AGENDA

Planning Committee Meeting to be held at
Preston Town Hall,
284 Gower Street Preston
on Tuesday 9 March 2021 at 6.30pm.

5.1 APPLICATION FOR PLANNING PERMIT - D/103/2020 24A - 26 Harbury Street, Reservoir

TP06 S
244 L 26 HARBURY ST
RESERVOIR
MULTI UNIT DEVELOPMENT
 FIRST FLOOR PLAN
 SCALE 1:100 @ A1
IKONOMICUS
 DESIGN STUDIO

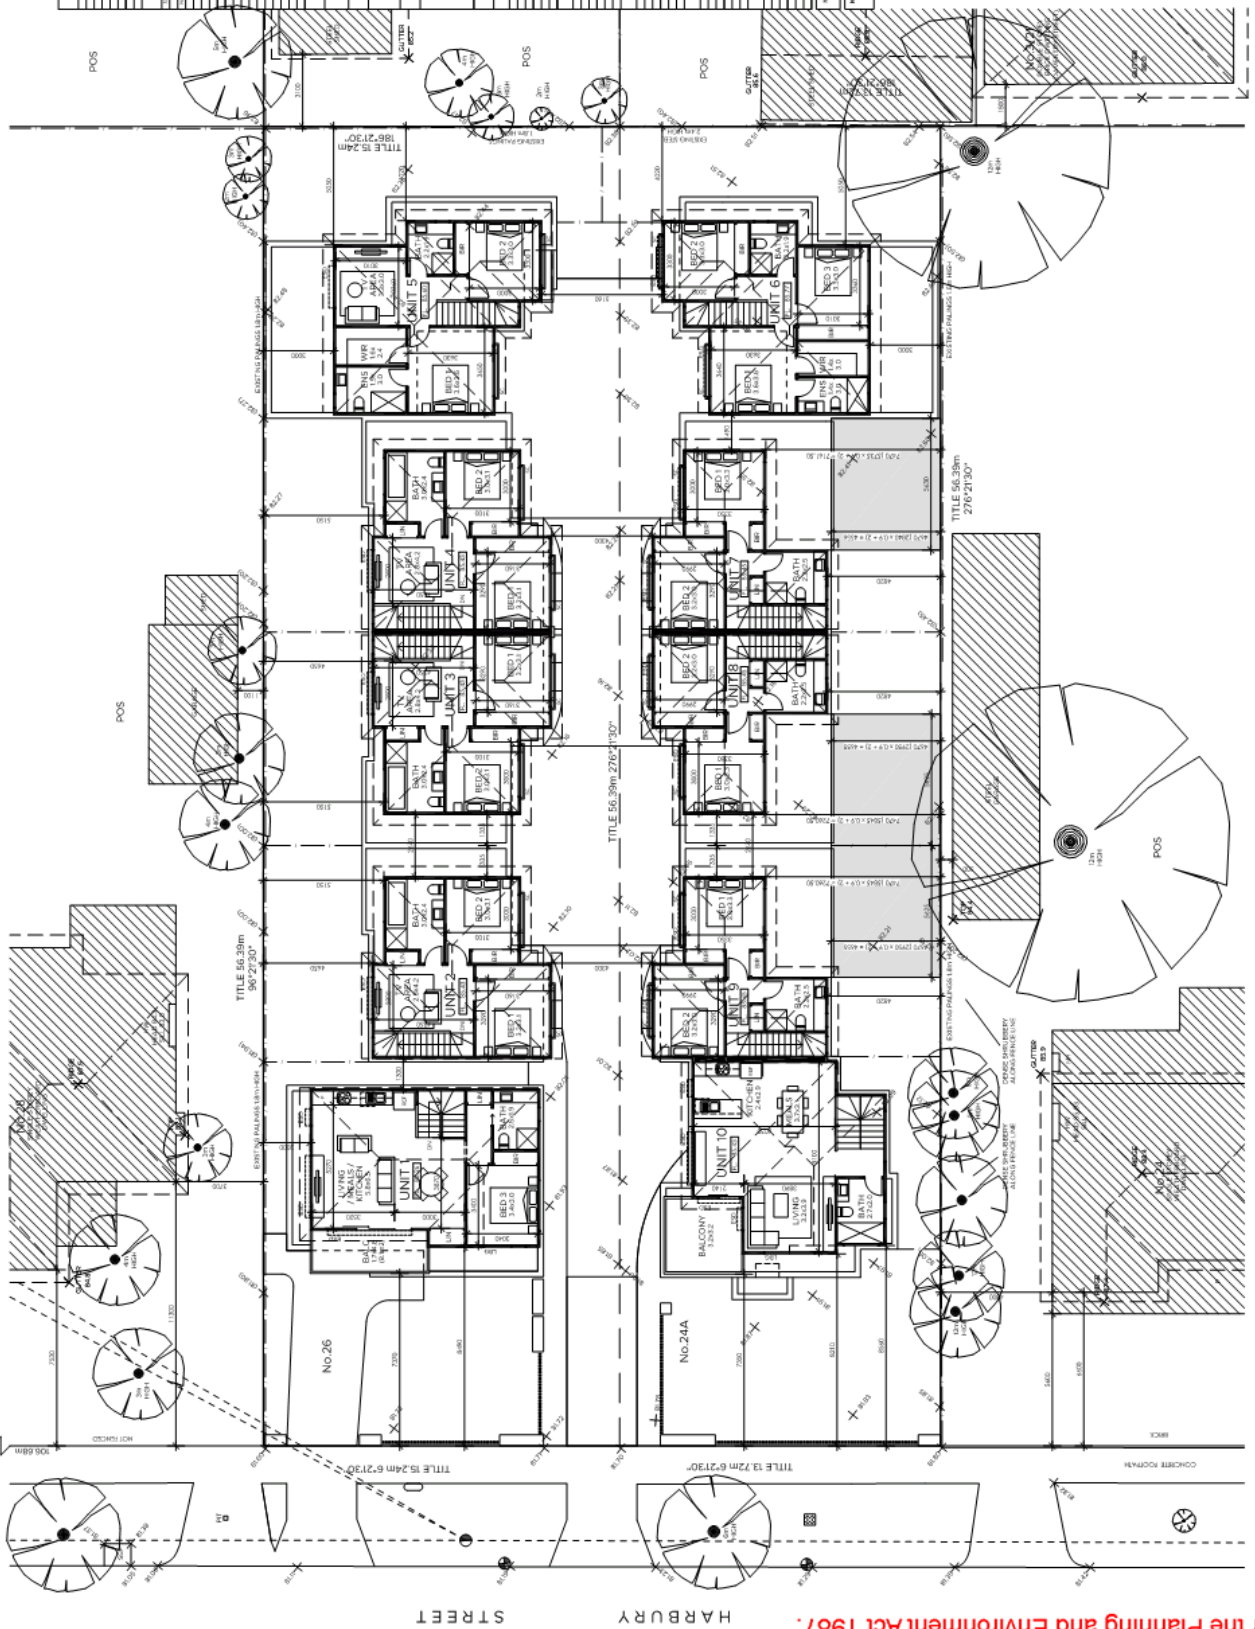
The above windows are to be modified so that the fixed obscure glazing to a height of 1.7 metres shown for these windows is replaced with clear glazing and fixed external screens to a height of 1.7 metres, similar to the internal elevation upper floor habitable room window treatments.

- Unit 6 Bedroom 3: Replace fixed obscure glazing to a height of 1.7 metres with the provision of a fixed external screen similar to the internal elevation upper floor habitable room window treatments.
- Units 2, 3, 4 & 5 TV Area: Replace fixed obscure glazing to a height of 1.7 metres with the provision of a fixed external screen similar to the internal elevation upper floor habitable room window treatments.

FRONT ELEVATION VIEW

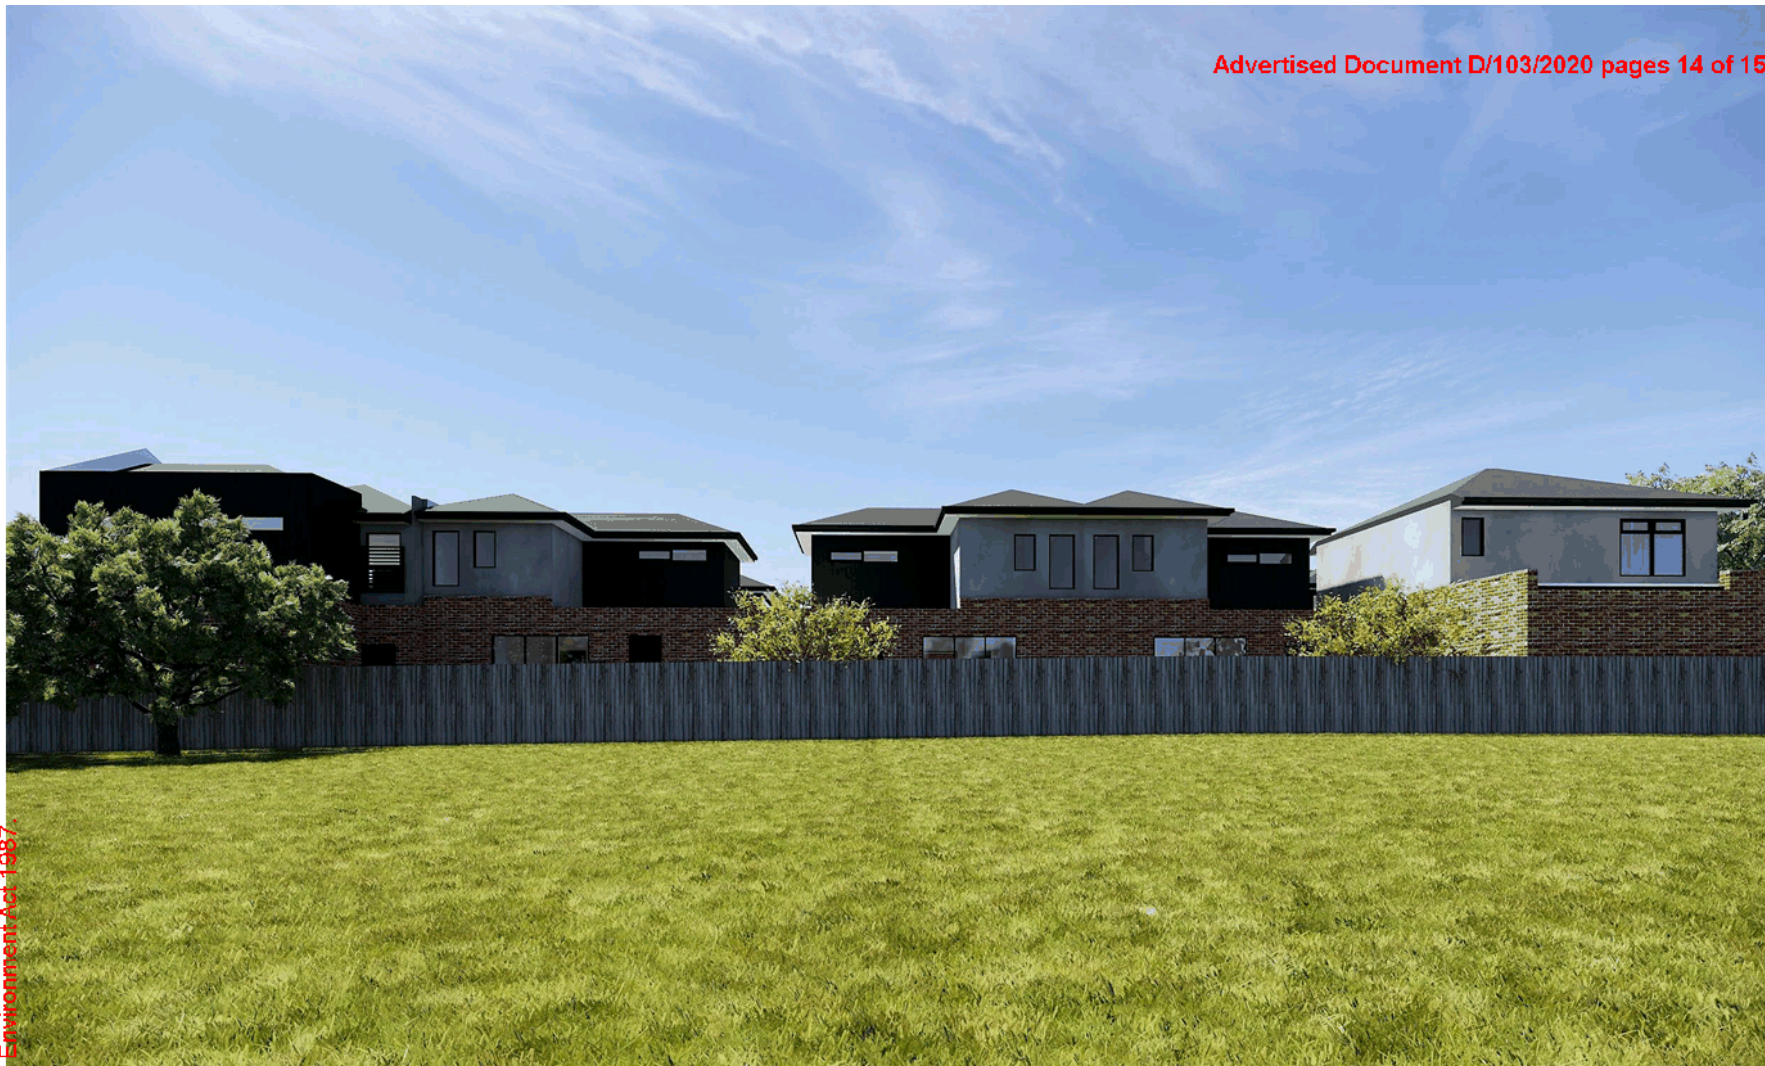
The use of glass balustrade for the first floor balconies should be replaced with metal slats as seen in the front fence design. This will provide a visually cohesive presentation to the street and ensure a greater level of privacy to the balcony areas.

City Designer	<p>No objection, subject to condition included in recommendation relating to:</p> <ul style="list-style-type: none"> • Reduced use of render materials • Remove hipped roof forms and replace with combination of gable ended roofs and flat roofs. • Replacement of glass balcony balustrades with slatted metal balustrades. • Entry porches to be better defined • Increased landscaping.

Department/Authority	Response
	<p>Officer's comments: The above suggested changes can be requested via conditions of any approval as follows:</p> <ul style="list-style-type: none"> • Render materials can be reduced and replaced with the metal cladding used elsewhere on the elevations. • Glass balcony balustrades can be replaced with slatted balustrades to match the front fence design. • Dwelling entries can be better defined through the use of canopy cover over the porches. • The reference plan provided by the applicant shows the inclusion of a greater level of landscaping including a medium canopy tree at the eastern end of the accessway. This can be converted into the plans via conditions. • It is not considered necessary to seek changes to the hipped roof forms as the hipped roof forms primarily present the side and rear boundaries of the site and there is sufficient interest in the presentation of the development to the street. Furthermore, any changes to roof forms, such as gable ends, to the side and rear elevations could result in increased height of built form to adjoining sites and compromise solar access to the southern secluded open space areas.
